**ADDENDUM No. 6 - February 5, 2016****GENERAL**

LAMOUREUX PAGANO ASSOCIATES ARCHITECTS 108 GROVE STREET, SUITE 300 WORCESTER, MASSACHUSETTS 01608  THE AMERICAN INSTITUTE OF ARCHITECTS	CLIENT INFORMATION: Worcester Public Schools  City of Worcester Massachusetts, 01605	PROJECT TITLE:  Nelson Place Elementary School  35 Nelson Place, Worcester, MA 01605	DRAWING NAME: Revised Detail 3/A6.22		SHEET REF. NO. See dwg.
			DATE: 02/08/2016	DRAWING NUMBER: ADD6	A-002
			SCALE: 3" = 1'-0"

**Nelson Place Elementary School  
35 Nelson Place  
Worcester, MA 01605**

## Partial Main Level Reflected Ceiling Plan - Section A-A

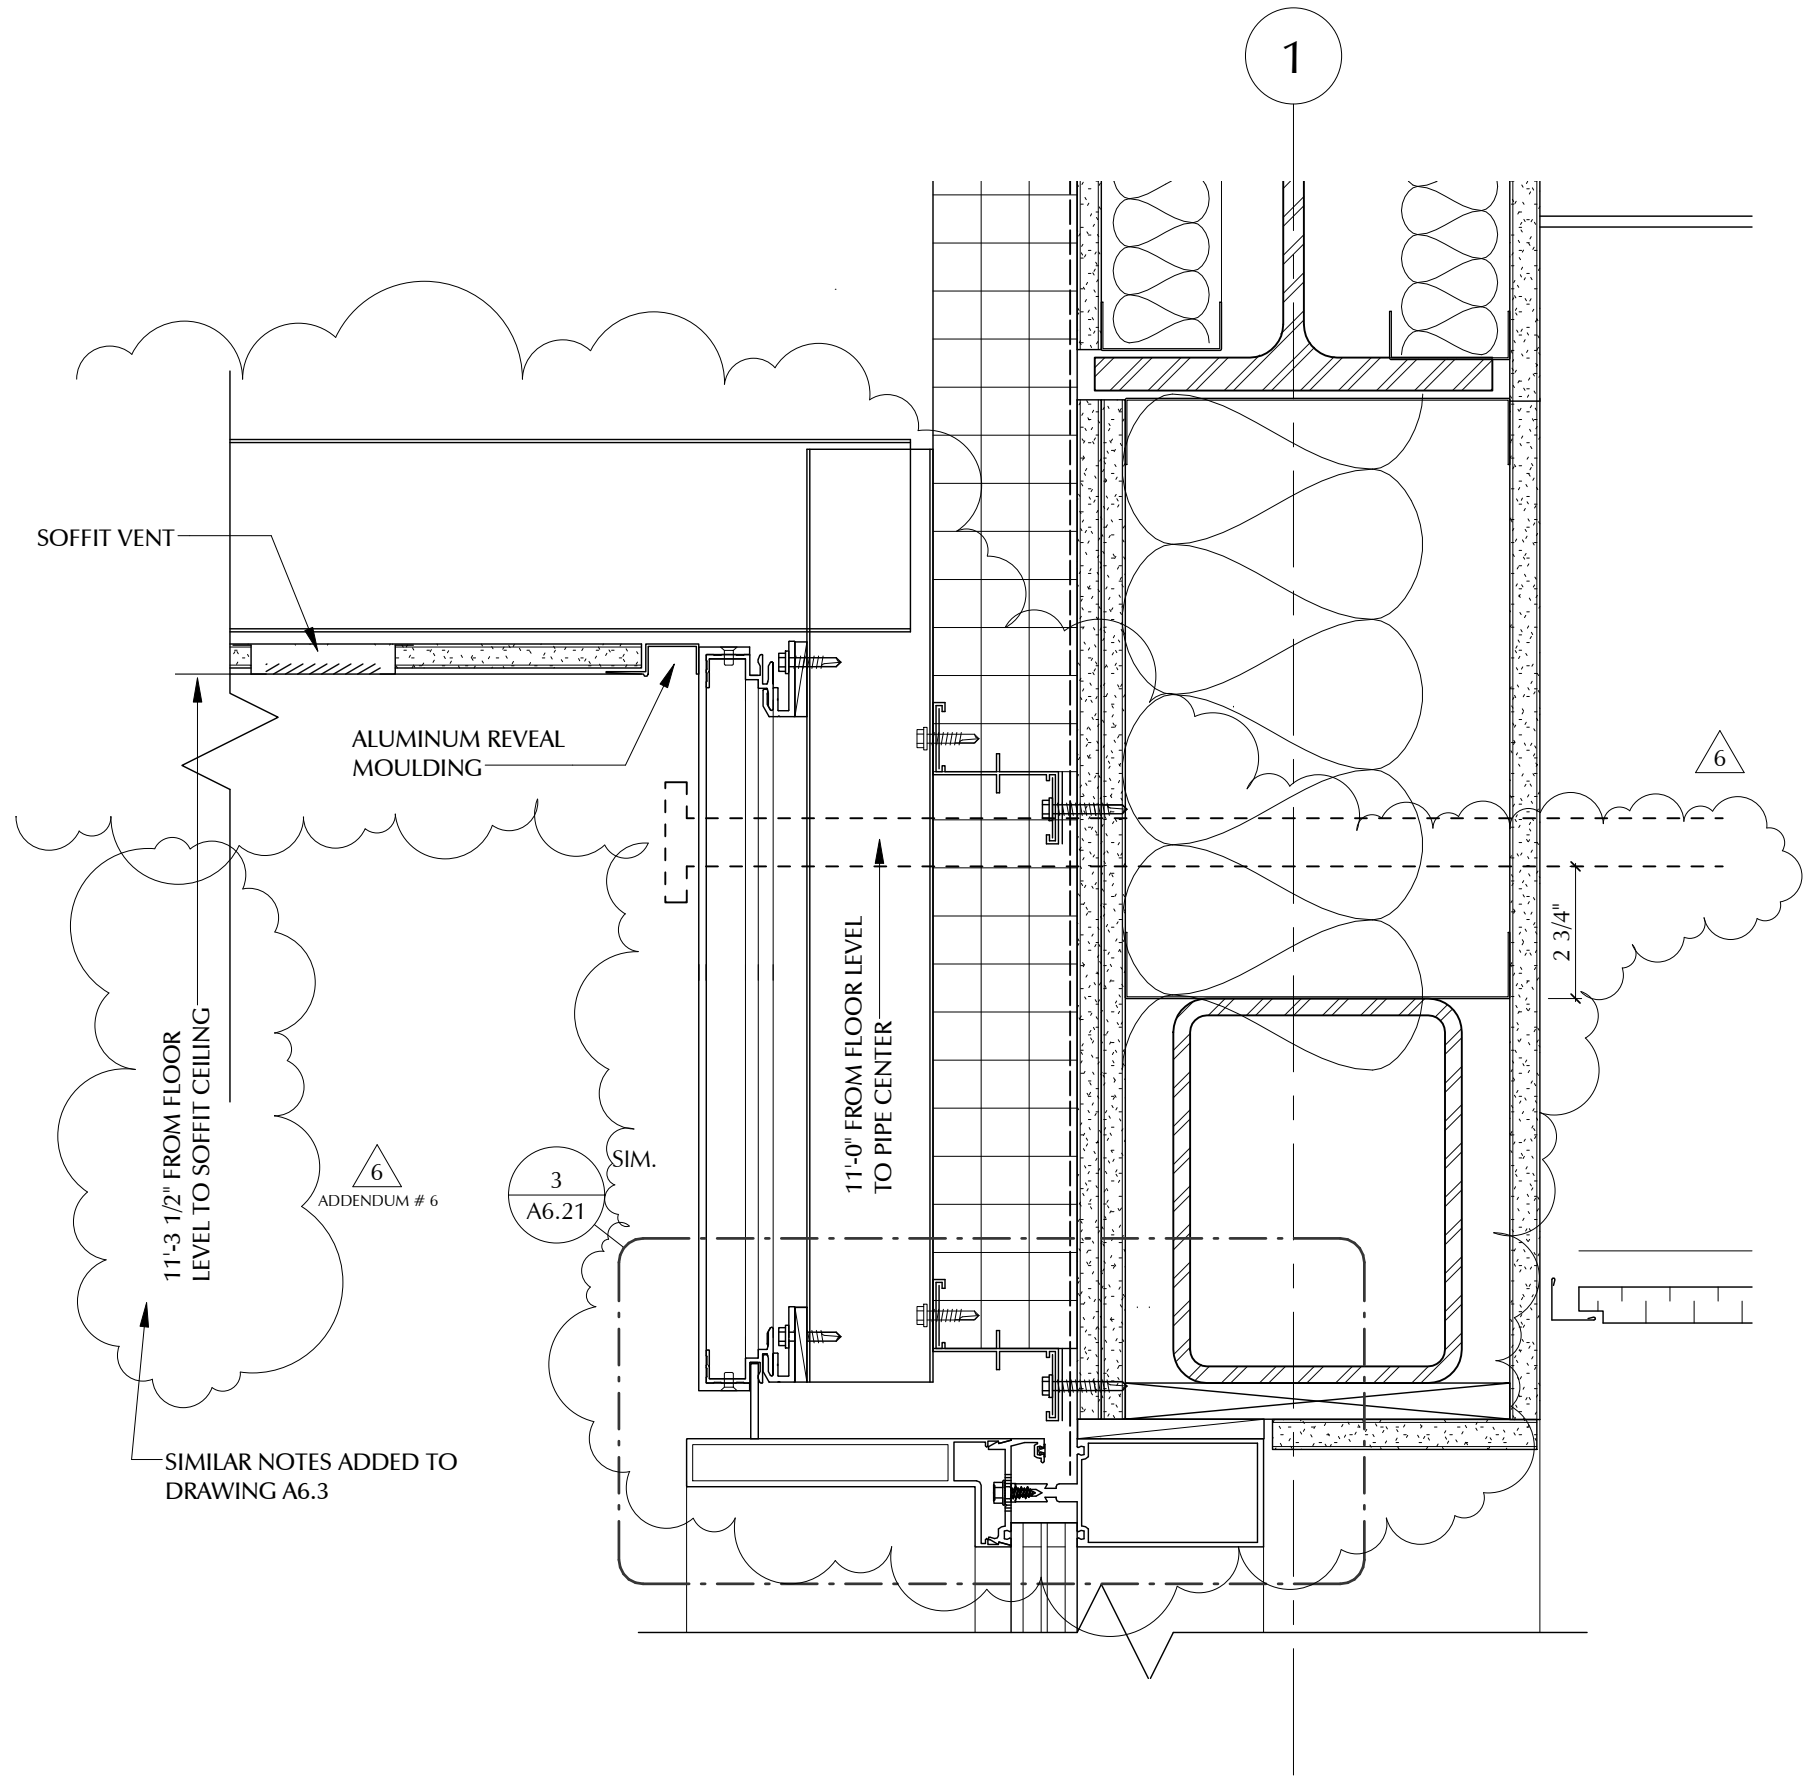
- A. Add exterior soffit ceiling height see ADD6 A-001.

3  
A6.22

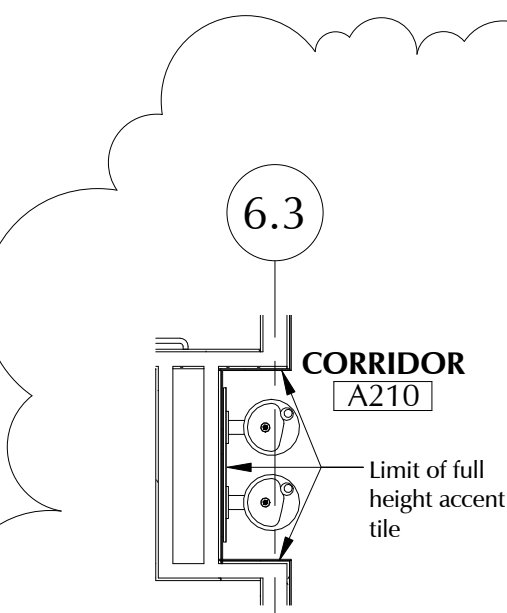
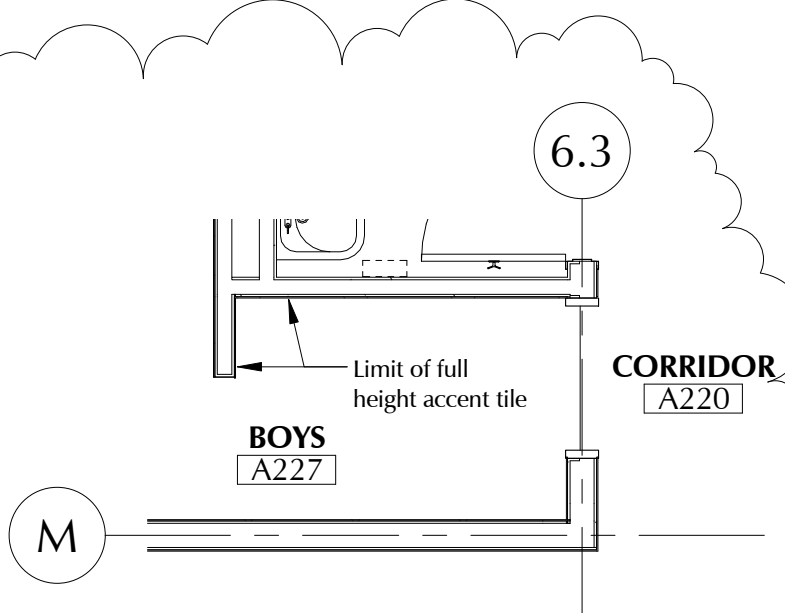
- B. Revised wall section 3 per detail 3/A6.22 revisions. Refer to sketch ADD6 A-002.

- A. Revised detail 3, steel tube shape, sprinkler pipe location, raised soffit height and surrounding construction. Refer to sketch ADD6 A-002.  
B. Revised detail 5 to reflect exterior ceiling height revision and extension of metal panel return to DAFS.

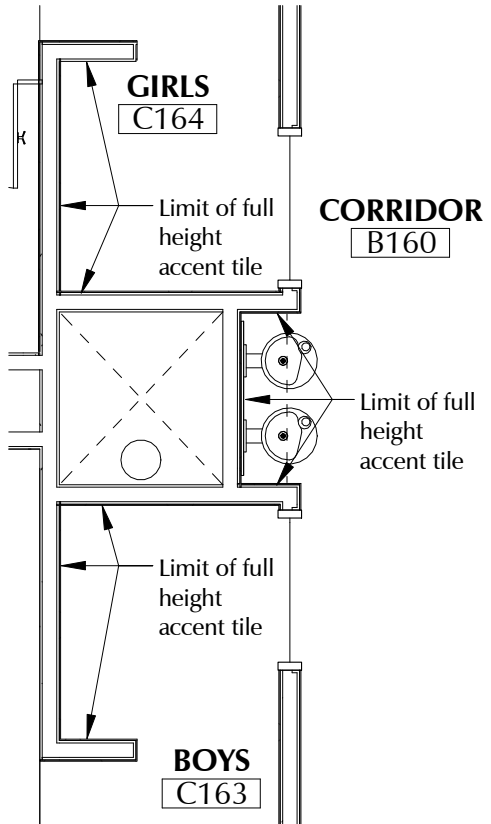
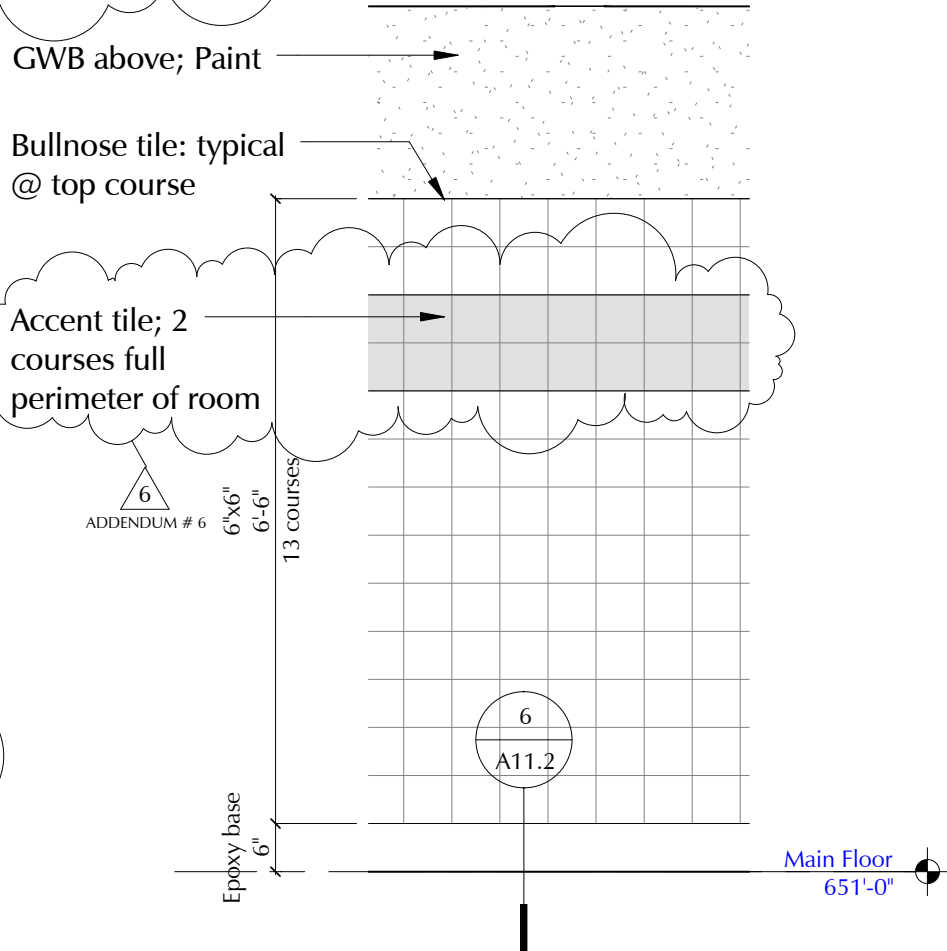
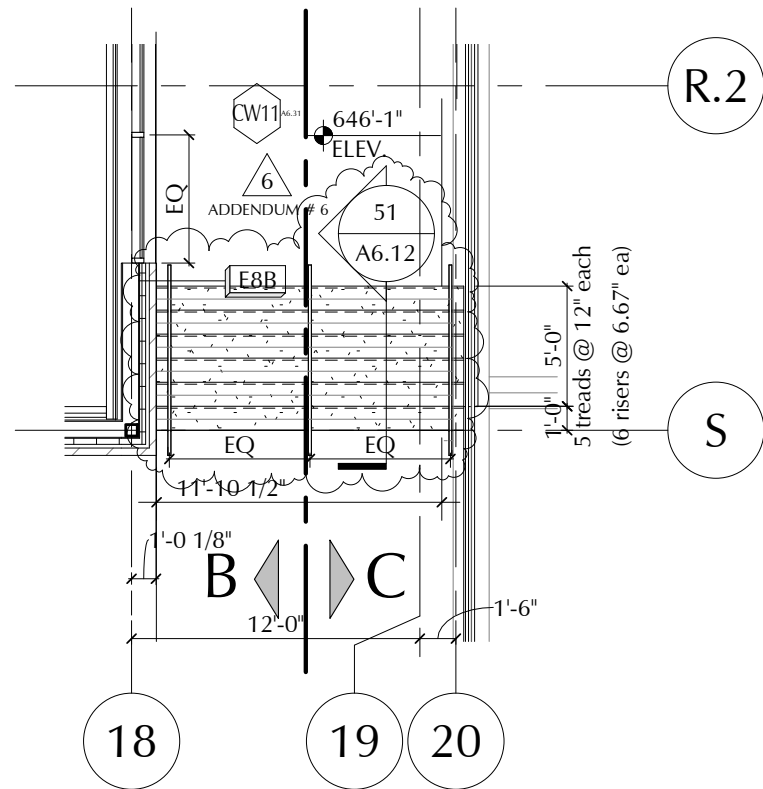
- A. 1/A8.7: Change note and bathroom entrance from “Ceramic tile” to “Ceramic accent tile”

51 Exterior Stair Detail  
A6.12 Scale: 3/4" = 1'-0"

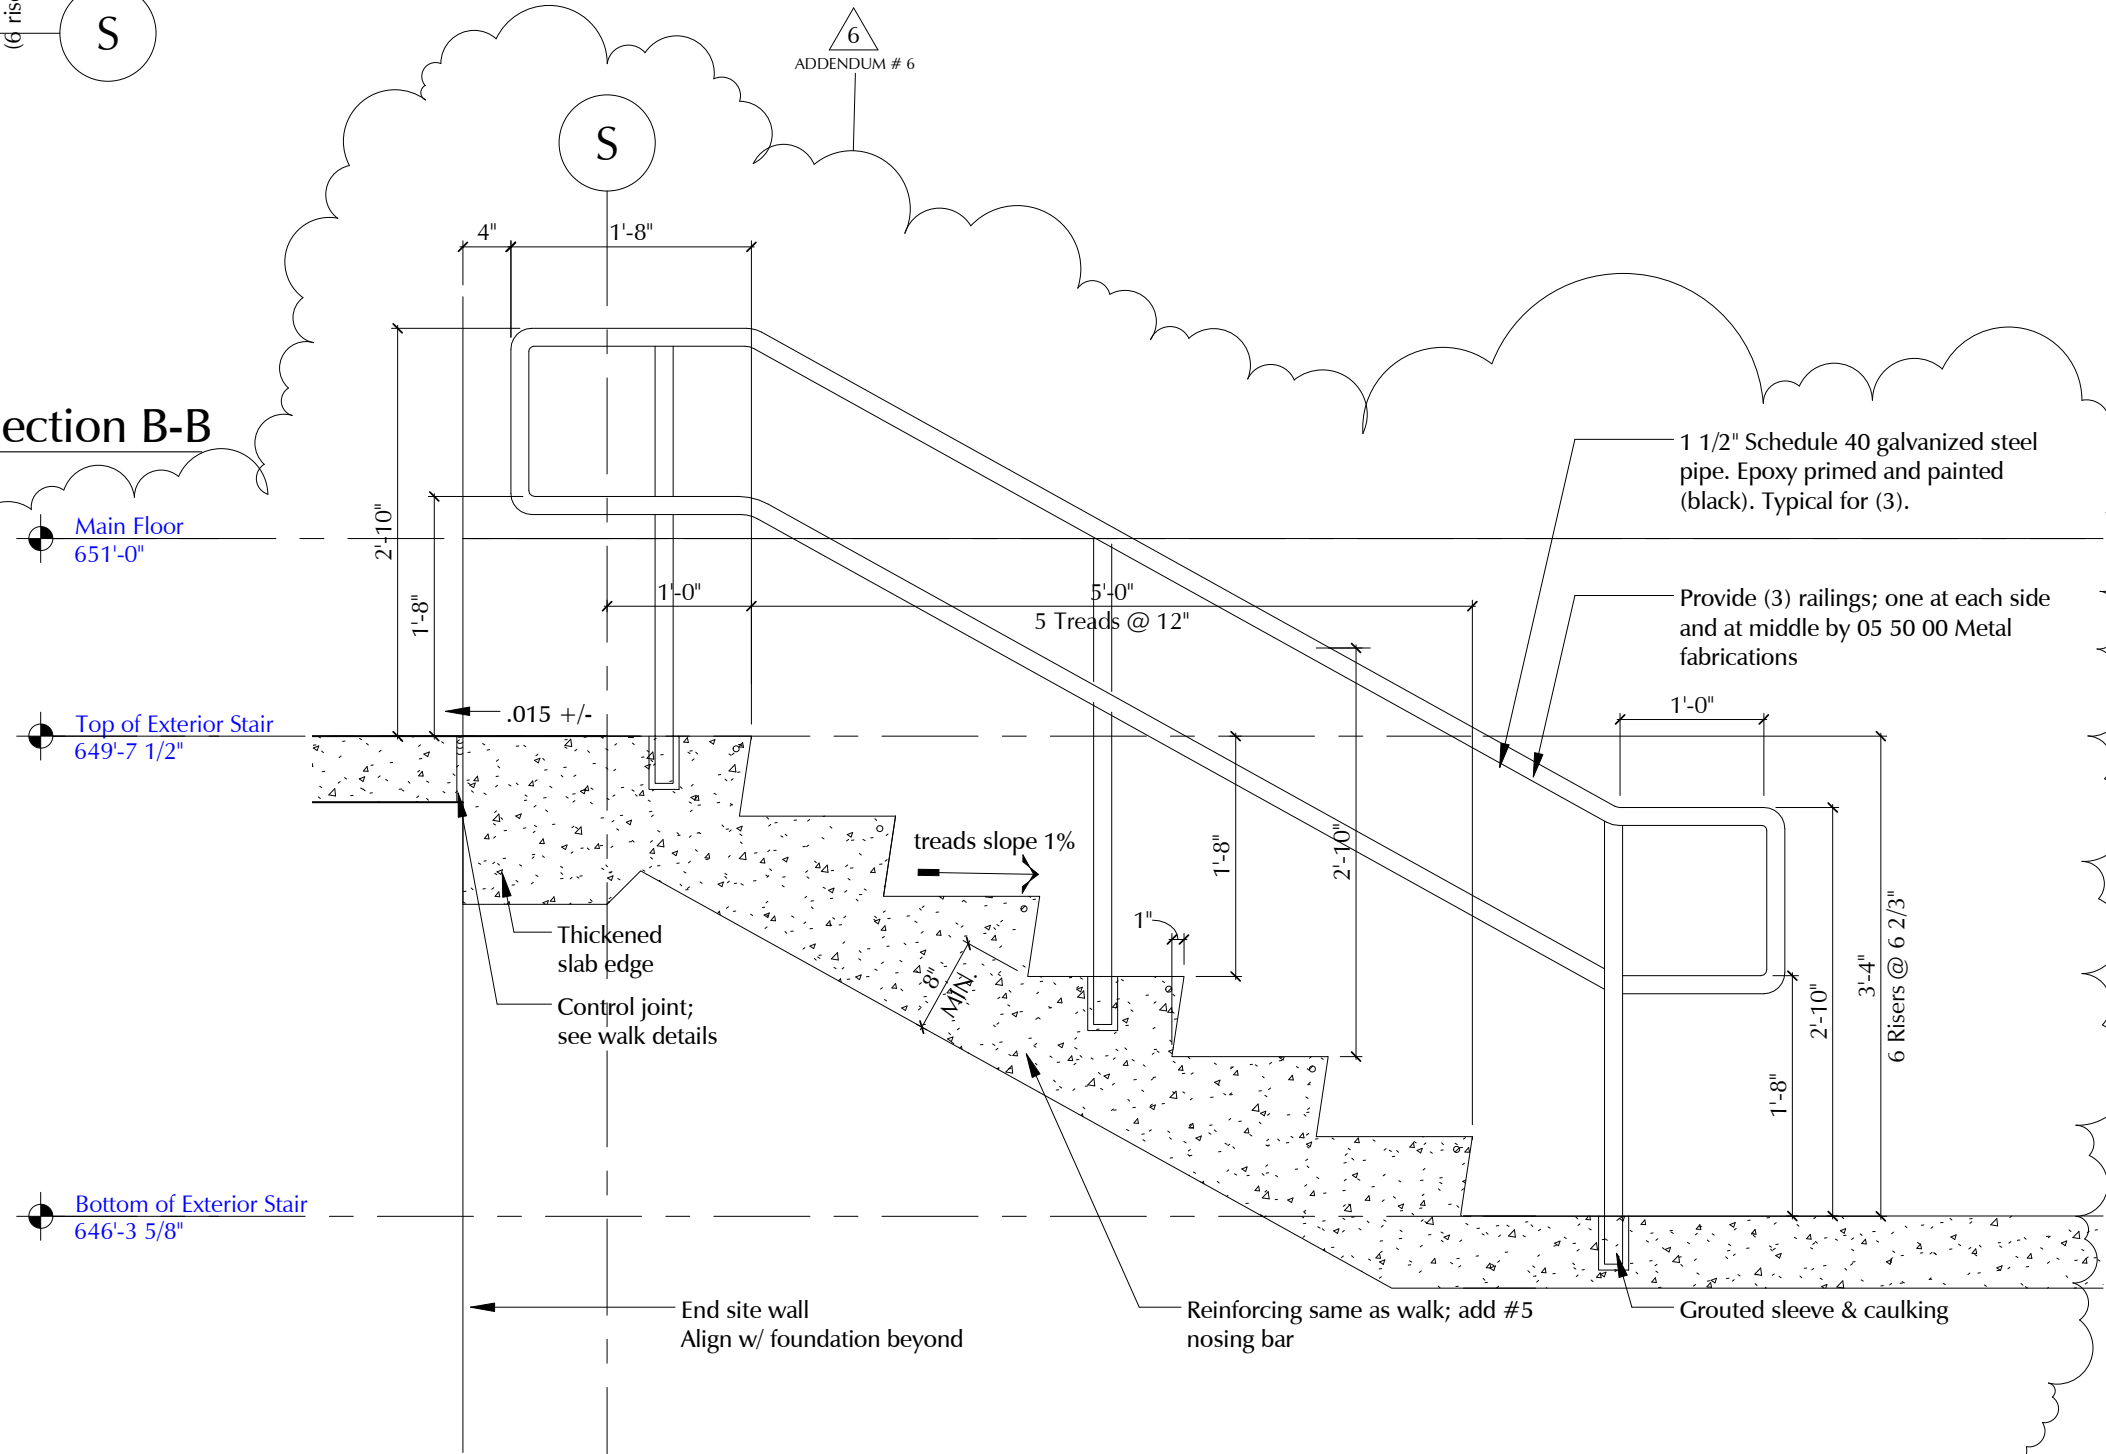
- A. Add Drawing Detail 51. See SKA-003.

<b>DRAWING NAME:</b> Footing Coordination		<b>SHEET REF. NO.</b> S3.1
<b>DATE:</b> 02/03/16	<b>DRAWING NUMBER:</b>  <b>SK</b> <hr/> <b>S-004</b>	
<b>SCALE:</b> 1/8" = 1'-0"		
<b>FILE NAME:</b> .DWG

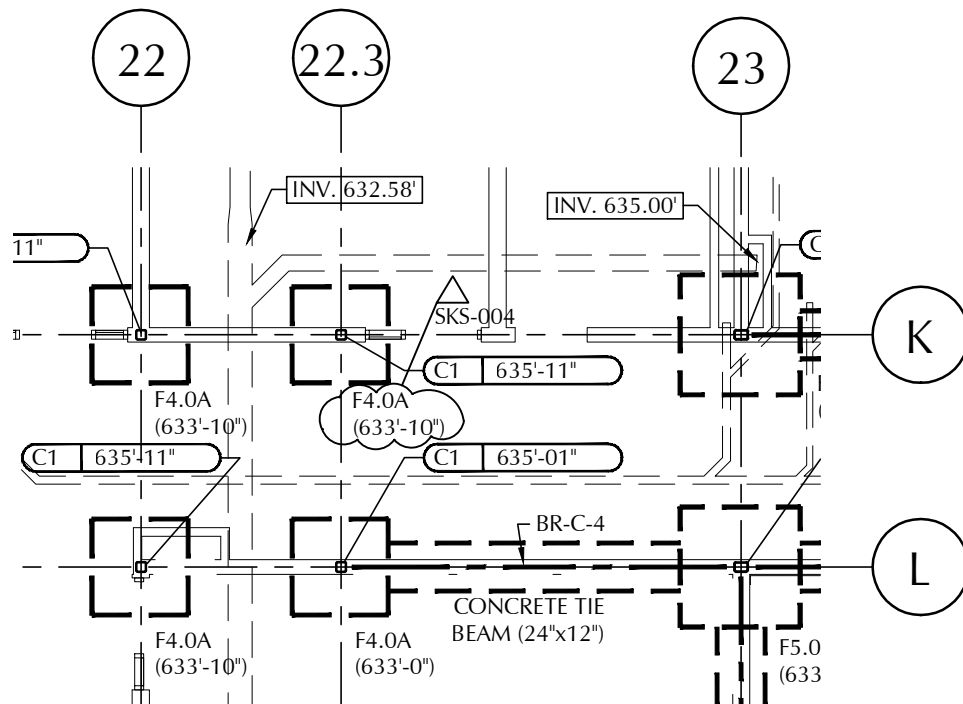
Footing depth revised to coordinate with underslab piping.

SK S-005 Brace Coordination w/ Ramps, dated 2/5/16

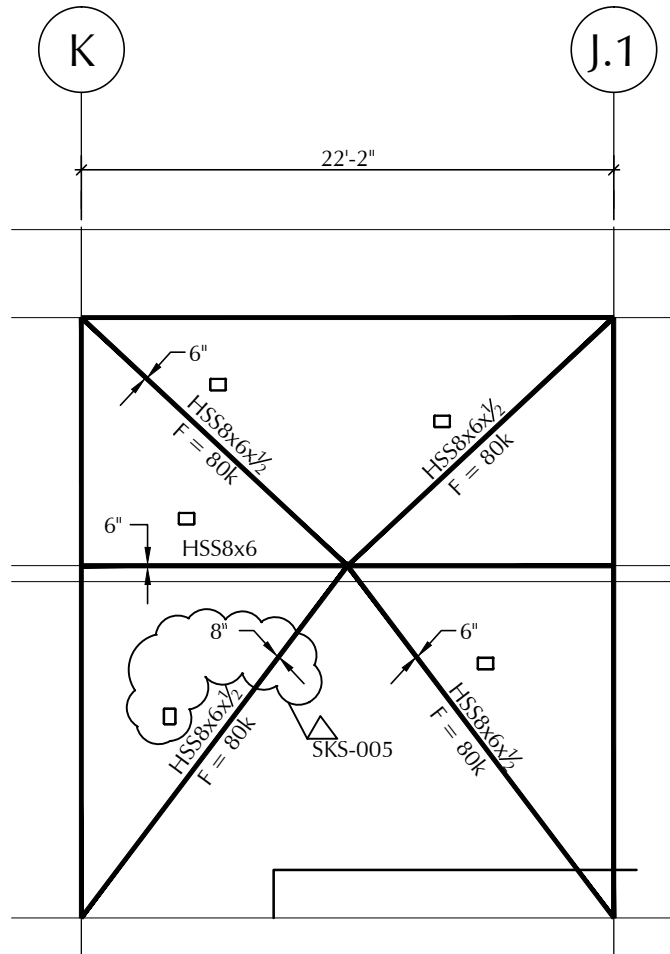
Brace revision at BR-B-14 and girt revisions at Media Center, per the attached sketches.
